Amendments/Additional Information

Re-roofing the conservatory at The Falcon Inn - NYM/2015/0894/FL

RE-ROOFING THE EXISTING CONSERVATORY
THE FALCONINN, WHITBY ROAD, CLOUGHTON

Dwg.no : 1505-2A

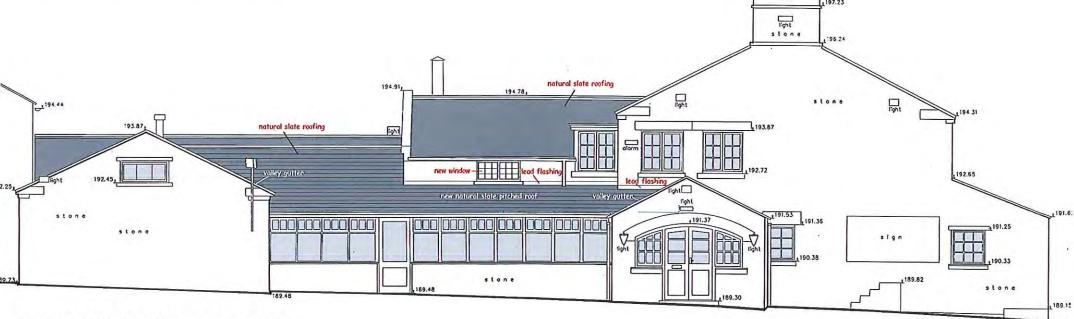
Further to our recent phone conversation, Lattach a copy of drawing no. 1505-2A indicating a reduced roof pitch to the conservatory. I trust this alleviates the concern regarding the ratio of exposed walling to slated roof.

A 16.01.16 conservatory roof pitch reduced
